BEFORE THE PUBLIC UTILITIES COMMISSION OF THE STATE OF SOUTH DAKOTA

In the Matter of the Application by Crowned Ridge Wind, LLC for Facility Permit to Construct a 230kV Transmission Line and Associated Facilities From Codington County to Big Stone South Substation EL-17-50

APPLICANT'S RESPONSES TO STAFF'S FIRST SET OF DATA REQUESTS TO CROWNED RIDGE WIND, LLC

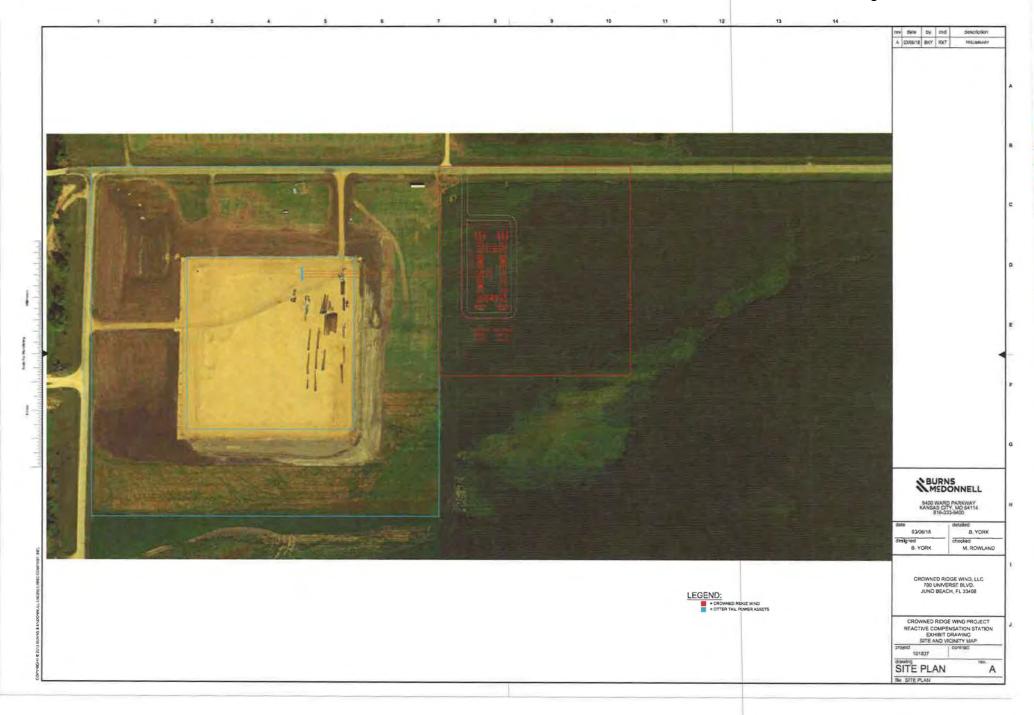
1-6 Refer to Page 9 of the Application. Crowned Ridge states the reactive power compensation substation will require approximately 12 acres of land. Provide a general layout map of the reactive power compensation substation on the referenced acreage. Compare and contrast the relative size of the reactive power compensation substation to the Big Stone South Substation.

Although Crowned Ridge purchased 12 acres for the reactive compensation substation site, only 1.93 acres will be permanently impacted. A representative layout map of the reactive power compensation substation on the referenced acreage is attached as Attachment 1, Staff DR 1-6. The dimensions of the reactive power compensation substation are approximately 225 feet x 375 feet or 1.93 acres compared to the dimensions of the Big Stone South Substation, which are approximately 650 feet x 670 feet or 10 acres. Thus, the reactive compensation substation is approximately 20% the size of the Big Stone South Substation.

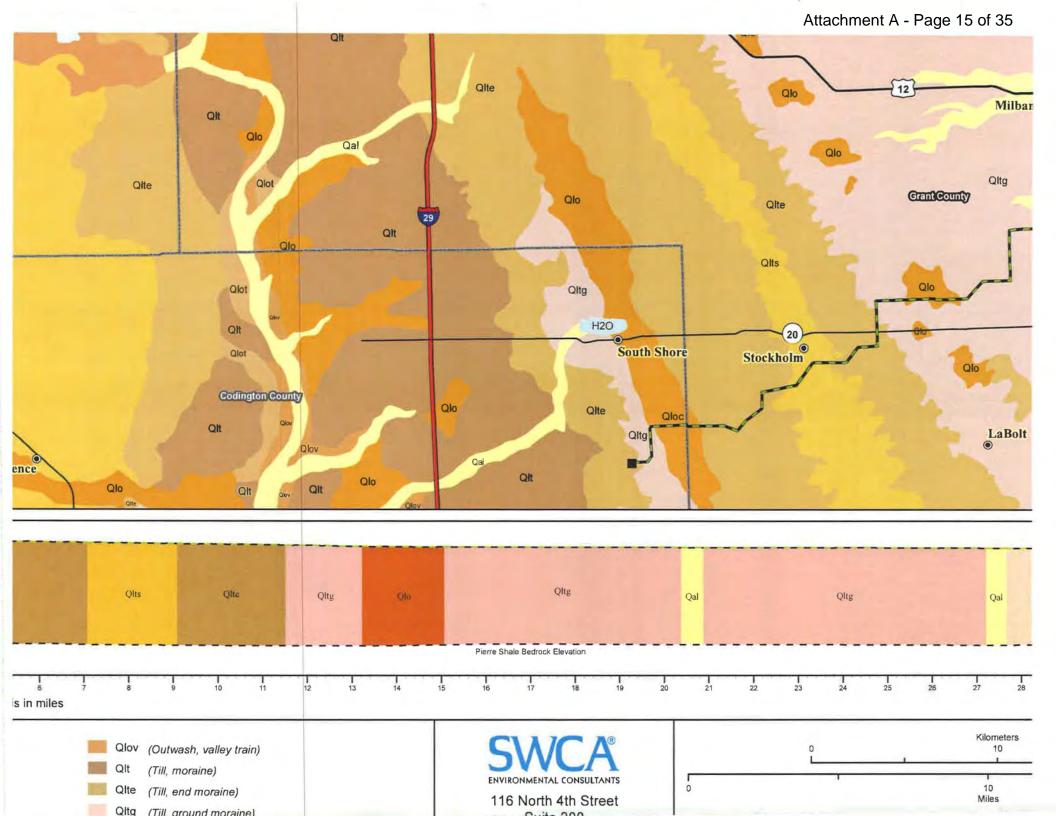
1-12 Pursuant to ARSD 20:10:22:14(3), please provide a map showing "...sufficient cross-sections to depict the major subsurface variations in the siting area."

Attached as Attachment 1 to Staff DR 1-12 is a map showing "...sufficient cross-sections to depict the major subsurface variations in the siting area."

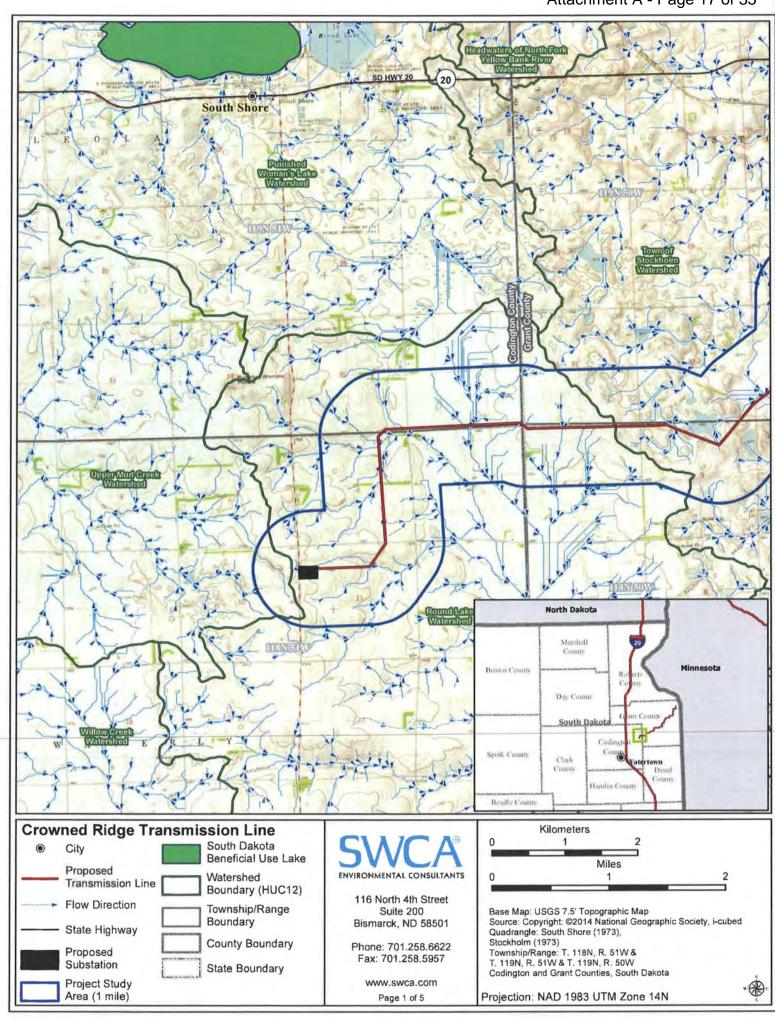
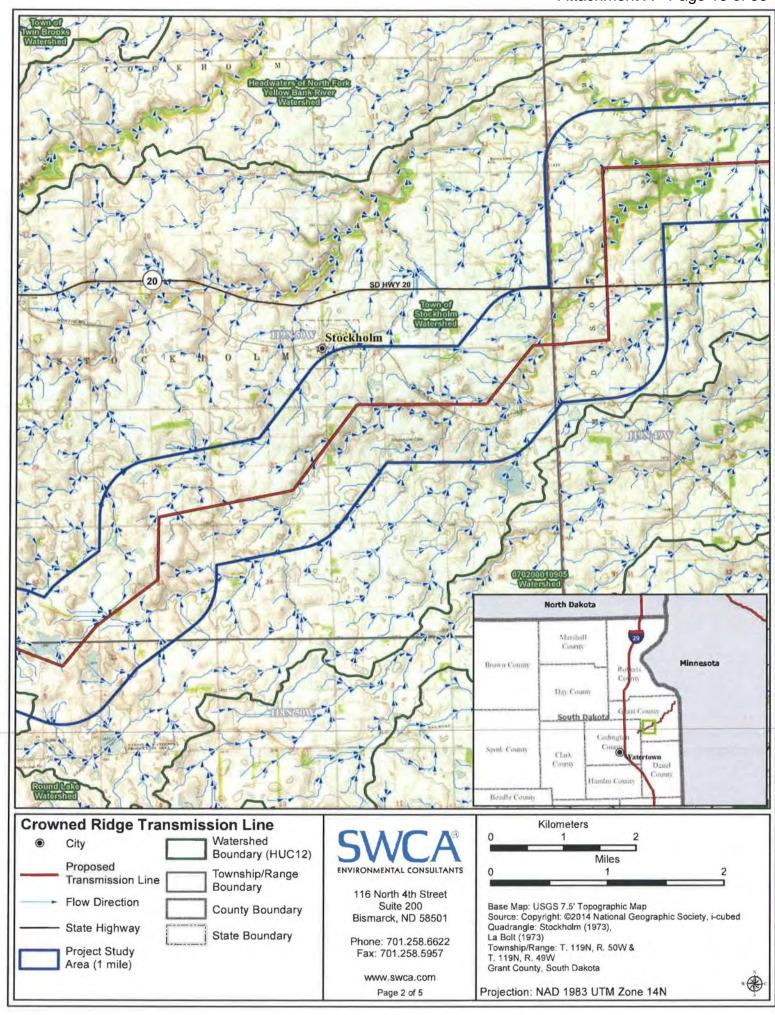
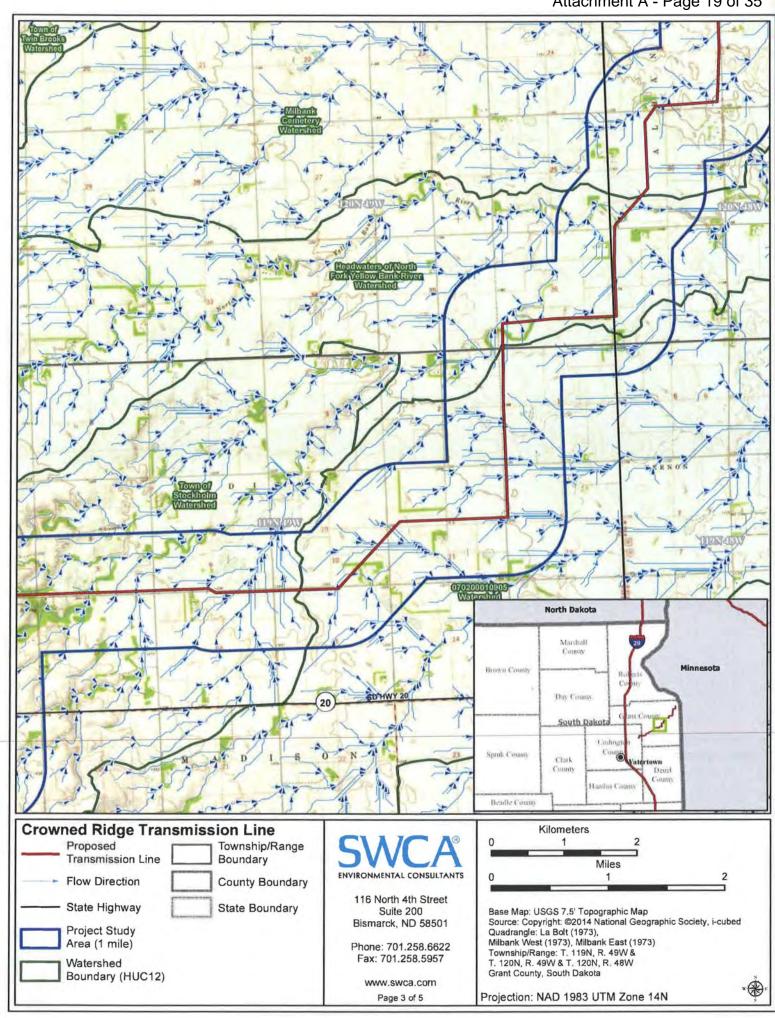
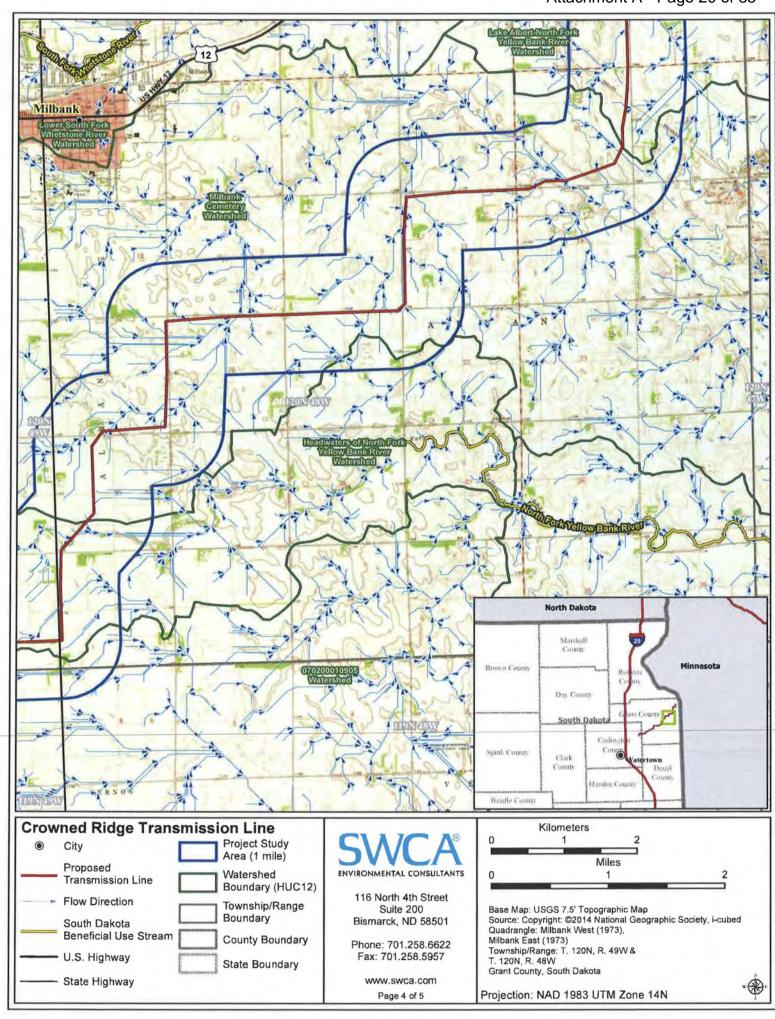
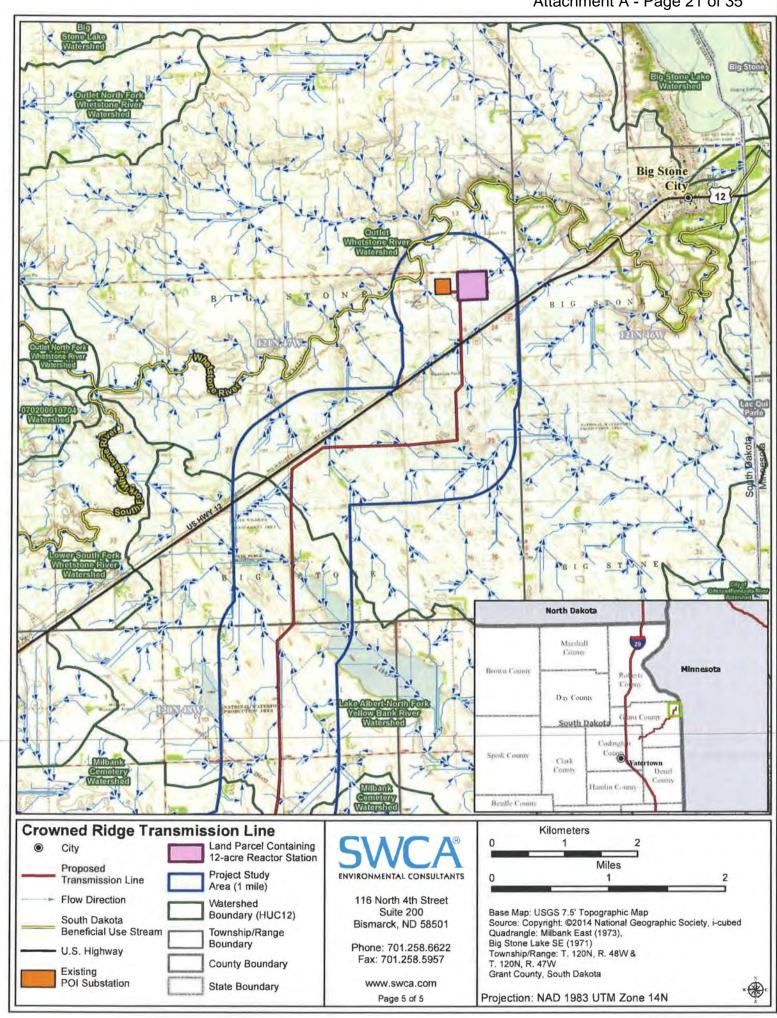
1-13 Refer to ARSD 20:10:22:15 regarding surface water drainage patterns. Provide a map drawn to scale of the transmission site showing surface water drainage patterns before and anticipated patterns after construction of the facility.

Attached as Attachment 1 to Staff DR 1-13 is a map drawn to scale of the transmission site showing surface water drainage patterns before construction of the facility. The Applicant intends to restore all temporary impacts as close as possible to the original contours and consistent with storm water permits.

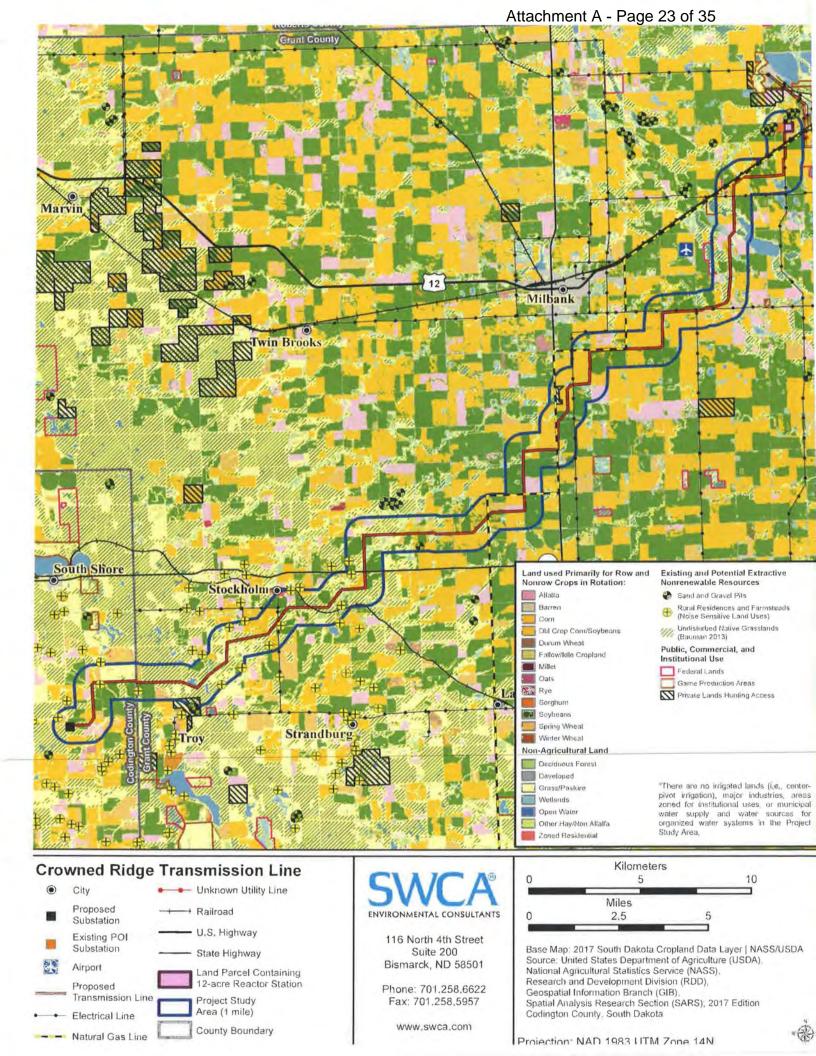
1-14 Refer to Exhibit 10 and ARSD 20:10:22:18(1). Submit a map that complies with the classification system described in administrative rule. Indicate the land uses described in (a) through (l) that are not present in the Project Area.

Attached as Attachment 1 to Staff DR-1-14 is a map that complies with the classification system described in administrative rule, indicating the land uses described in (a) through (l) that are not present in the Project Area.
